Town of Rolesville  
502 Southtown Circle  
PO Box 250  
Rolesville, North Carolina 27571

**RE: Frazier Farm Park CDs  
Case Number: CID-23-05  
Response to 1<sup>st</sup> TRC Review Comments  
2020110039**

#### Sheet C1.01 Existing Conditions

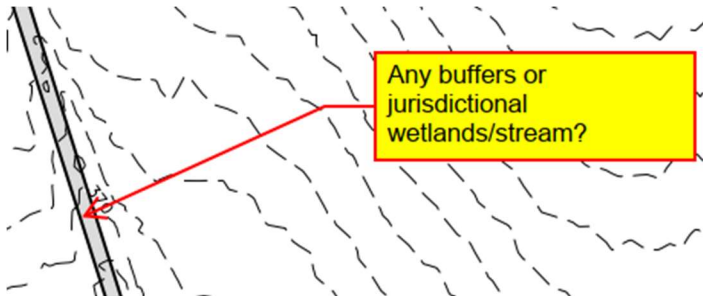
1. Suggest adjusting to make easier to read, (mask).

2. Any buffers or jurisdictional wetlands/stream?

**McAdams Response: Masking has been added to labels for clarity.**

**McAdams Response: There are no buffers associated with this wetland. Please see included delineation report.**

Sheet C1.10 Overall Demolition Plan

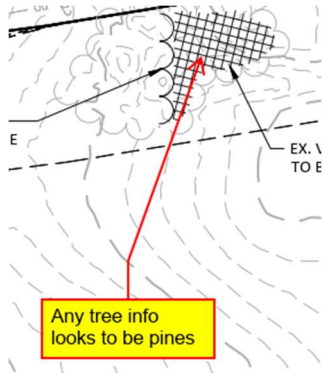
3. Are there any trees or utilities to be removed? Nothing is shown on this sheet. If none, consider removing from legend.

**ARE THERE ANY TREES OR UTILITIES TO BE REMOVED? NOTHING IS SHOWN ON THIS SHEET. IF NONE, CONSIDER REMOVING FROM LEGEND**

**McAdams Response: Items have now been removed from legend.**

Sheet C2.00 Overall Site Plan

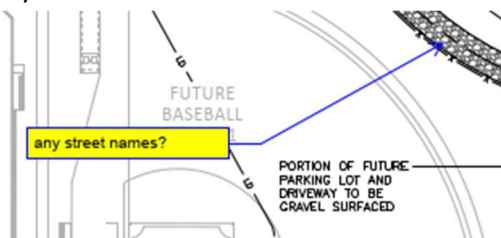
6. Any street names?

**McAdams Response:** Street names have not been established for Phase 1A of the project. It is our understanding that street names will be designated and signage added during the design and construction of the future park build-out.

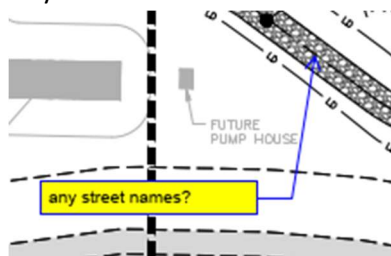
7. Any street names?

**McAdams Response:** Street names have not been established for Phase 1A of the project. It is our understanding that street names will be designated and signage added during the design and construction of the future park build-out.

Sheet C2.01 Site Plan: Area 'A'

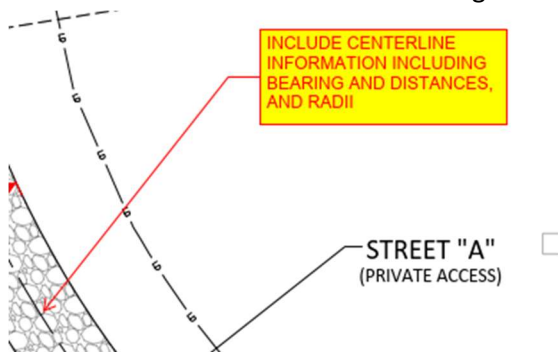
9. Include centerline information including bearing and distances, and radii.

**McAdams Response:** Alignments with bearing, length, and radii have been added to the site plans.

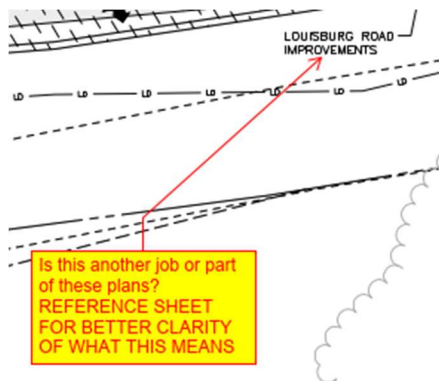
12. Is this another job or part of these plans? Reference sheet for better clarity of what this means.

**McAdams Response:** Note has been updated to reference sheet C7.00.

Sheet C2.02 Site Plan: Area 'B'

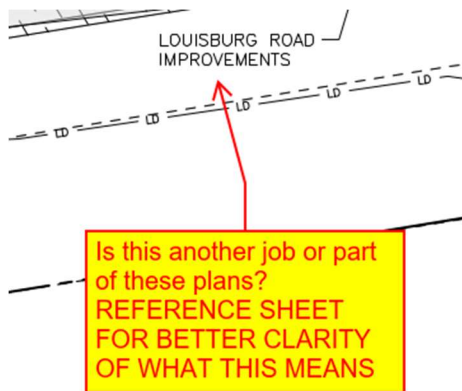
16. Is this another job or part of these plans? Reference sheet for better clarity of what this means.

**McAdams Response:** Callout has been updated to reference sheet C7.00.

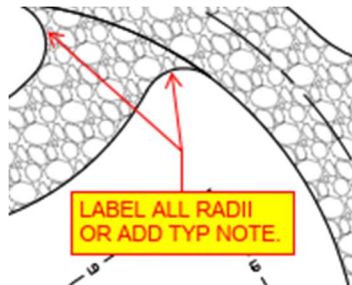
18. Label all radii or add typ note.

**McAdams Response:** All radii have been labeled on the site plan sheets.

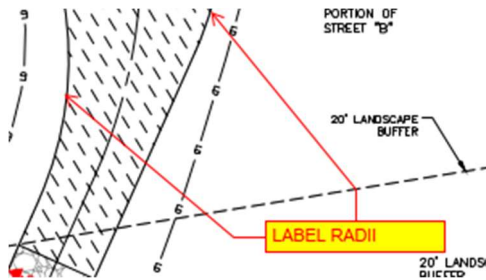
19. Label radii.

**McAdams Response:** All radii have been labeled on the site plan sheets.

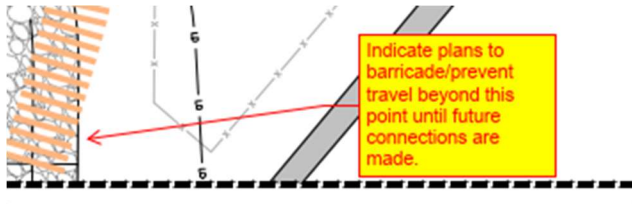
21. Indicate plans to barricade/prevent travel beyond this point until future connections are made.

**McAdams Response:** A barricade has been added and called out on sheet C2.02.

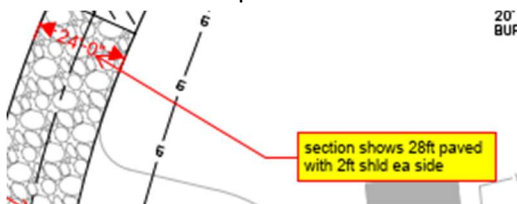
25. Section shows 28ft paved with 2ft shld ea side.

**McAdams Response:** Labels and typical road section have been added for clarification.

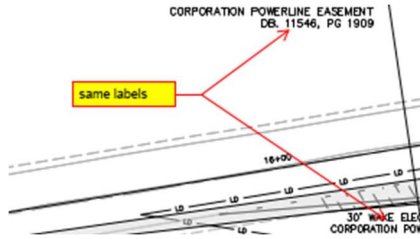
27. Same labels.

**McAdams Response: Duplicated labels have now been removed.**

Sheet C2.04 Site Plan: Area 'D'

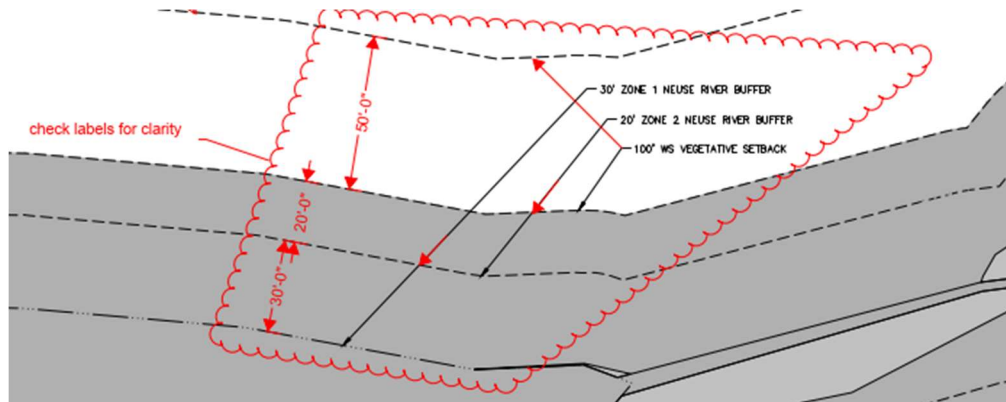
39. Check labels for clarity.

**McAdams Response:** Labels have now been updated.

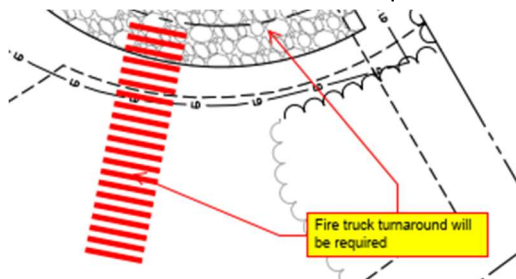
41. Fire truck turnaround will be required.

**McAdams Response:** Turn around is now provided at the new roadway cutoff.

Sheet C3.01 Grading & Drainage Plan: Area 'A'

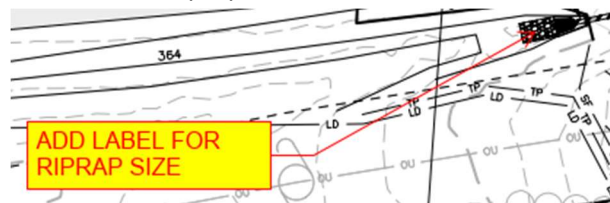
45. Label or add to legend.

McAdams Response: Block has been frozen to display only on phase 2 erosion sheets.

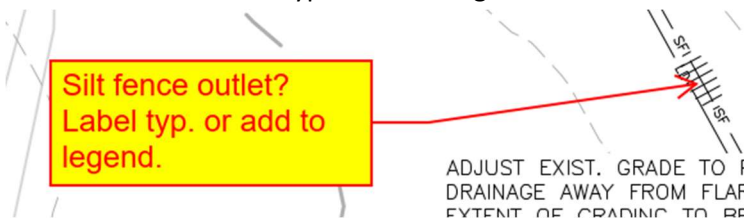
48. Include slope.

**McAdams Response:** Labels have now been updated to include slope.

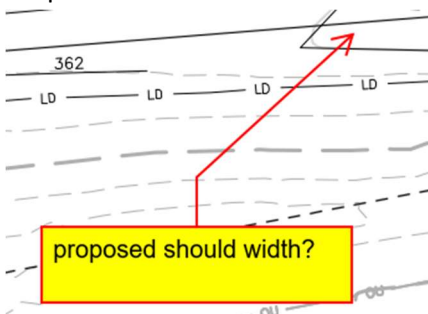
51. Reference elevations are not entirely clear, however adding labels to future proposed contours would be confusing. Can proposed grade be adjusted to meet requirements to avoid any confusion?

**McAdams Response:** Reference contours are shown to illustrate future conditions, but can be turned off if desired. Phase 1A grading has been designed in an effort to minimize grading and storm drainage re-work during design and construction of future phase.

Sheet C3.03 Grading + Drainage Plan: Area 'C'

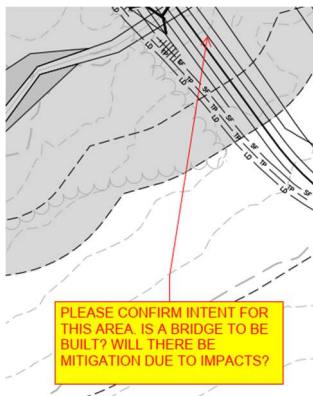
75. Verify intent of grading and/or culvert location. It looks like contours slope away from culvert inv. In? Is inv. In elevation correct?

**McAdams Response: Culvert is no longer part of the scope for this plan submittal.**

Sheet C5.00 Plan + Profile Street 'A', STA. 10+00 thru STA. 22+00

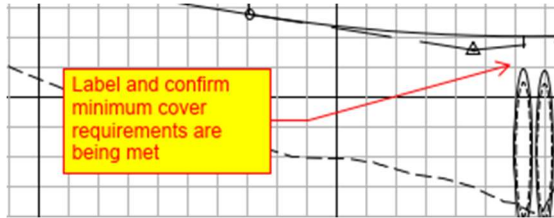
85. Label minimum bury depth (24" for storm).

**McAdams Response: Cover has been confirmed and minimum depth callouts have been added.**

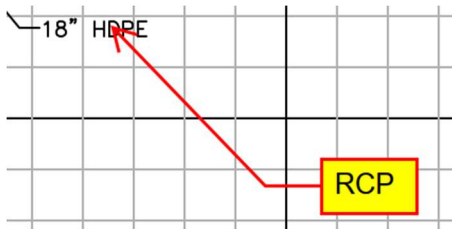
88. NCDOT review, looks to be missing check dams, wattles for SEC.

**McAdams Response: Erosion control review currently underway. These items will be added with revisions resulting from Erosion and Sedimentation Control review.**

Sheet C7.00 Louisburg Road Widening Plan

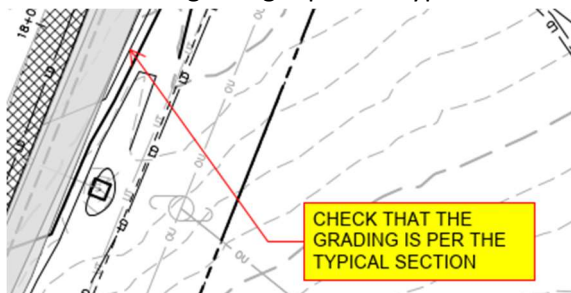
101. Check that the grading is per the typical section.

**McAdams Response: Plans have been updated.**

Sheet C8.00 Site Details

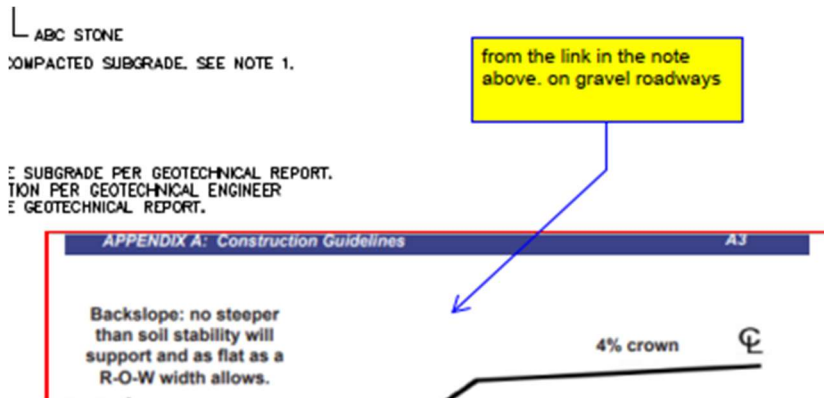
105. Good drainage will be important for a gravel section roadway. The FHWA recommends minimum 4% cross slope on the travel lanes (1/2" ft) and 1% cross slope on the shoulders (1"/ft). See

The gravel section should consist of a minimum 6" compacted ABC. This is consistent with the referenced FHWA publication for low volume truck traffic (0-5 trucks per day) and moderate subgrade bearing capacity (CBR > 10).

**McAdams Response: Gravel section has been updated.**

Sheet C8.01 Site Details

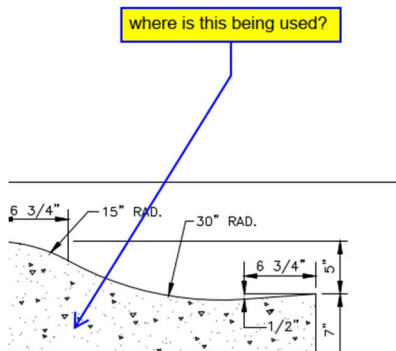
109. Are you doing a row? Public/private?

**McAdams Response: No ROW to be dedicated with the scope of this plan submittal.**

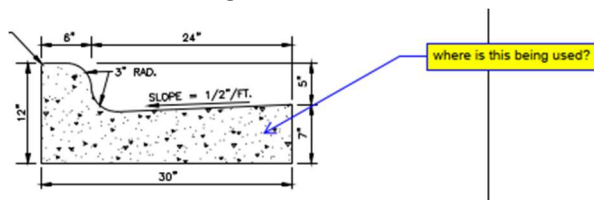
112. Where is this being used?

**McAdams Response: Curb call outs have been added on the site plan sheets, C2.00s.**

Sheet C8.03 Storm Drainage + Utility Details

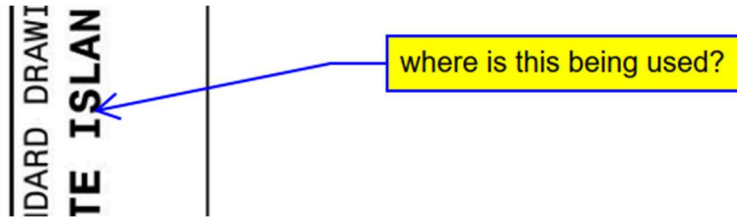
113. Please include details for erosion control measures, such as silt fence, silt fence outlet, tree protection fence, and inlet protection. For the storm system, RCP to be use within the influence of the gravel road (future paved) Town Public Works Director to review and approve if HDPE will be allowed in area not with in the influence of the road/parking areas.

**McAdams Response: Pipe material has been updated to RCP. Erosion control details are located on sheets C6.10 through C6.12.**

Storm Drainage Calculations – Page 7

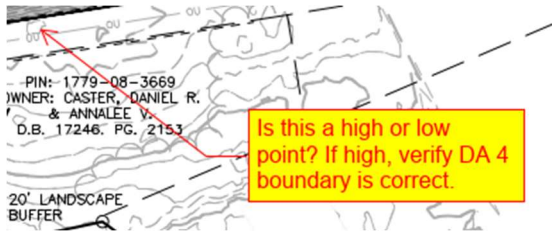
119. Confirm the boundary of DA 2 is correct. It appears to be following existing rather than proposed contours.

**McAdams Response: Boundary of DA 2 has been updated.**

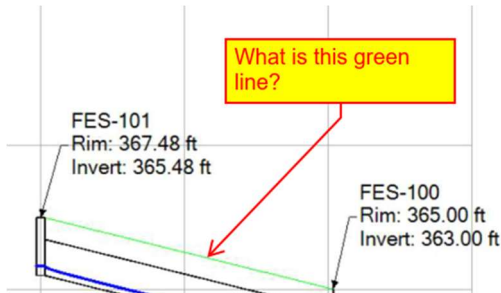
122. Please label all structures/FES's. We cannot match profiles to the plan without proper labeling.  
**McAdams Response: The post drainage area map now includes labels for matching profiles to the plans.**

Storm Drainage Calculations - Page 8

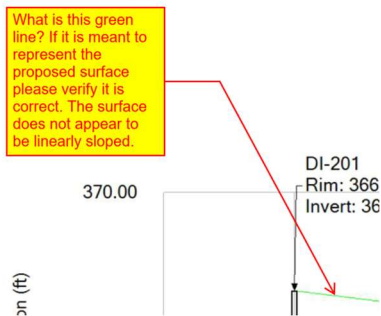
125. What is this green line?

**McAdams Response: Green line has been removed from HGL profiles.**

Storm Drainage Calculations – Page 9

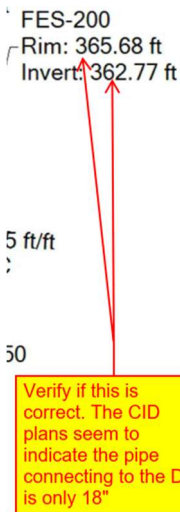
129. Verify if this is correct. The CID plans seem to indicate the pipe connecting to the DI is only 18".

**McAdams Response: Structure information has been updated.**

Storm Drainage Calculations – Page 10

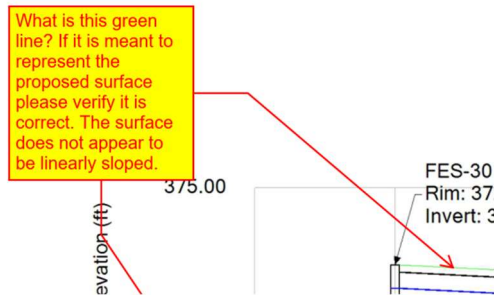
130. Please make sure plan view includes labels so we can match profiles to the plans.

**McAdams Response: Grading sheets C3.01 and C3.02 now include labels for matching profiles to the plans.**
